12 January 2011

- presents my final findings on a review of the operation of Wivenhoe Dam (including controlled releases) for compliance against the Flood Mitigation Manual for the period 12 December 2010 to date (Flood Event), and;
- provides advice on the prudence and appropriateness of the decisions and actions taken during the Flood Event regarding the operation of Wivenhoe Dam in light of the Flood Mitigation Manual's requirements and the circumstances of the Flood Event.

Wivenhoe & Somerset Dams – Storage Level Behaviour (as presented in Technical Situation Reports)

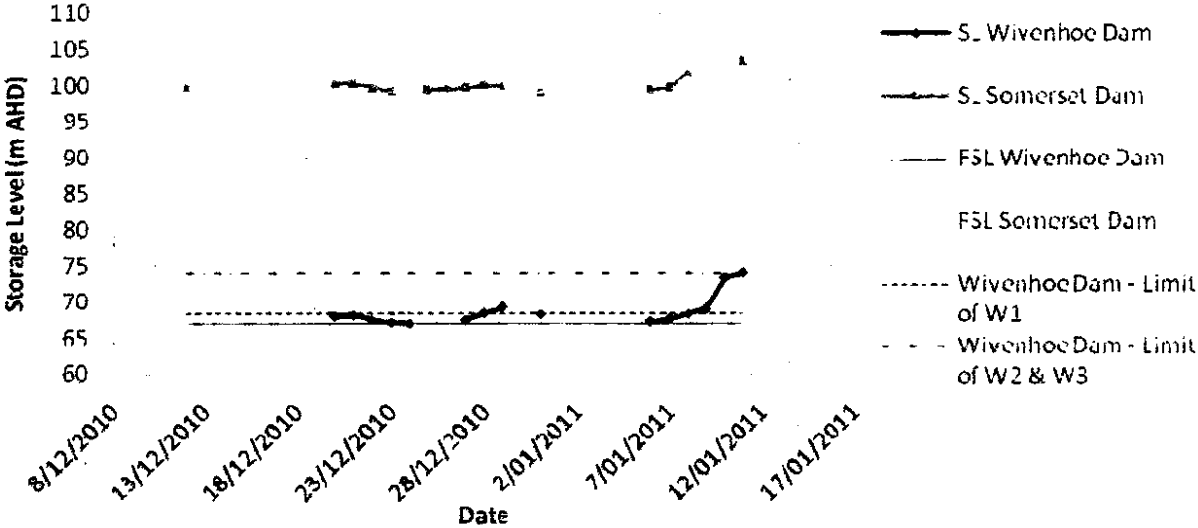
The Technical Situation Reports comply with the requirements of the new Communication Protocol. However, I feel that there could be more consistency in the information presented. There seem to be gaps in information presented such as storage levels (see spreadsheet and graph in Attachment A). It would be useful to specify the minimum information required to be presented in the Technical Situation Reports (storage levels, inflows, recent/current rainfall, forecast rainfall, releases from dams, estimated flows from downstream tributaries, current flood operating strategy for each dam and proposed change in strategy, gate and regulator operations, state of downstream road crossings etc). Most of the minimum information is already given, but not in a consistent manner. As a means of reviewing processes followed during a flood, it would be useful to present a timeline of the flood event showing graphs of storage levels and other data that can be easily presented in a graphical manner.
